REMARKS

Applicant respectfully requests reconsideration of the subject application in view of the amendments and remarks set forth herein. Applicant notes that attached to this amendment is a request to Change Attorney Docket Number. Applicant further notes that the Examiner, in rejecting the claims under 35 U.S.C. 112, 2nd paragraph, suggests that the claims appear to be a literal translation into English from a foreign document. Applicant respectfully submits the application was drafted in English in Australia, as was the complete specification for the PCT application.

FIG. 4

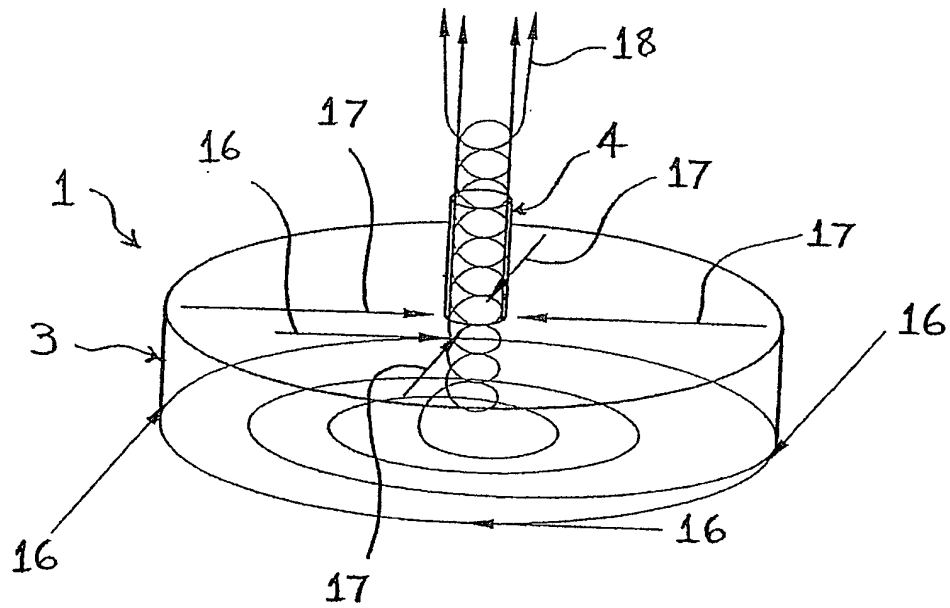
Applicant respectfully submits that the Examiner does not appreciate at least the following key elements recited in claim 1 as amended namely “at least one secondary upper layer that substantially follows a second flow path radially inwardly towards said central axis,”

and “said primary lower layer and said secondary upper layer interact and support each other in a non-destructive manner from peripheral side wall to said outlet”. The applicant submits that support for the amendment is found in the specification with particular reference to a description of Fig. 4 at page 6, last paragraph through to page 7.

claimed by the Applicant in amended claim 1 of the application. As can be seen in Fig. 4 of the Applicant's disclosure, the "primary lower layer" enters the chamber 1 from an inlet that is tangential to peripheral side wall 3 (outer perimeter) to create a vortex motion towards the center. The secondary upper layer 17 enters the chamber 1 from an inlet that is perpendicular and its direction of flow is radial. Please note that the arrows 16 represent the primary lower layer in Fig. 4 which are clearly tangential and the arrows 17 represent the secondary upper layer and are clearly radial. As clearly stated in the description, the primary lower layer 16 and the secondary upper layer 17 interact (mix) and support each other from the perimeter (side wall 3) to the central outlet 4 (recited in amended claim 1 as "support each other in a non-destructive manner from peripheral side wall to said outlet." The presence of these upper and lower layers do not break up the motion and effects of the vortex, but rather enlarge and heighten the effect of the vortex as the fluid moves towards the central axis (outlet 4).

FIG. 5

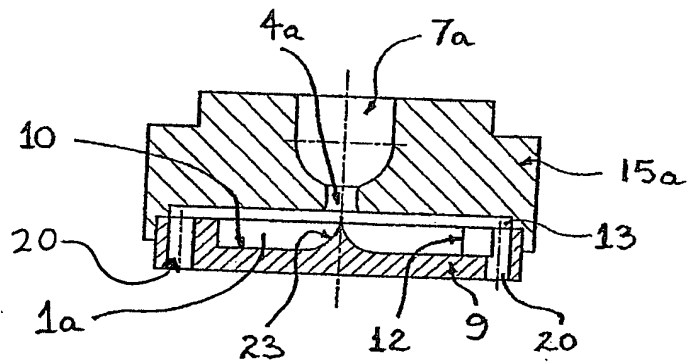
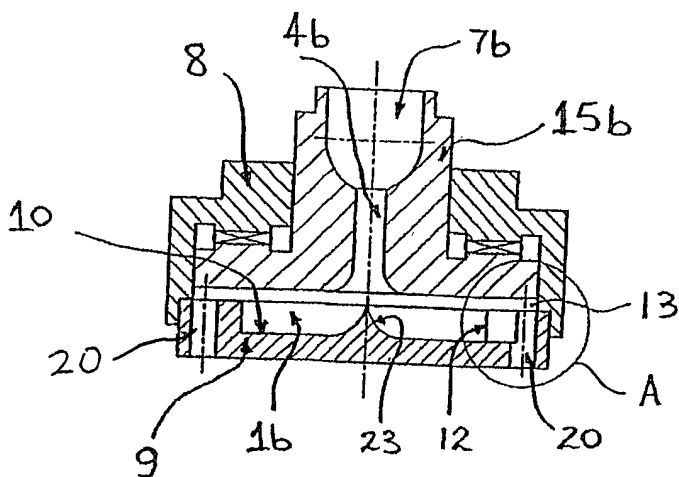
The Examiner has objected to the drawings for allegedly failing to show every feature of the invention specified in the claims. (See e.g., paragraph 2 of the Office Action.) Particularly, the Examiner states, “the ‘shower head’ of claim 7, the ‘plurality of inlets’ in claim 8 must be shown or the feature(s) canceled from the claim(s).” Applicant has amended claim 7 to recite the subject matter referenced by the Examiner directed to a “plurality of inlets” and claim 8 is amended to depend from claim 7 reciting the subject matter directed to a “shower head”. Applicant further amends Figures 5, 6 and 8 by way of the attached replacement sheets and annotated sheets to more clearly illustrate the subject matter of the present disclosure. Particularly, Applicant has set forth additional reference numerals (20) in Figure 5, 6 and 8 to clearly illustrate to the Examiner that the present disclosure illustrates embodiments having a plurality of apertures (20), each aperture (20) is associated with an inlet (11) thereby illustrating a plurality of inlets as recited by amended claim 7. (See Fig. 8, and specification, page 8, lines 3-5, “However, a portion of the flow as it passes through *the eight apertures 20* associated with *inlet ports 11* is urged circumferentially into the annular gap 13 between disc 9 and shower housing 15a or 15b.”) (*Emphasis Added.*)

Referring to amended claim 8 reciting at least in part “a shower head,” Applicant respectfully submits that the specification including the drawings fully support this claim recitation. In particular, the specification refers to several embodiments illustrated by the drawings as being a “shower head” in an exemplary embodiment. Applicant respectfully directs the Examiner to view Figures 5 and 6 in light of the description found on page 7 of the specification which states, “FIGS. 5 and 6 depict second and third embodiments of a *“shower head”* apparatus for regulating fluid flow through a spray nozzle that produce the primary lower layer 16 and secondary upper layer 17 flow conditions described with reference to the first embodiment of the invention shown in FIG. 4. FIG. 5 depicts a *shower head* having a “fixed volume” circular chamber 1a, whilst FIG. 6 depicts a *shower head* having a “variable volume” circular chamber 1b.” (*Emphasis Added.*)

Applicant respectfully submits that the drawings in view of the specification are sufficient to enable one having ordinary skill in the art to fully understand and appreciate that the apparatus associated with the present disclosure, at least in one embodiment, is a “shower head” as described at least by the passage cited above and in view of at least Figures 5 and 6

5, 6 and 8 and a second set of amended drawings titled “Annotated Sheets” showing a marked-up version of the amended Figures 5, 6 and 8. Applicant respectfully submits that no new matter is introduced by way of the foregoing drawing amendments.
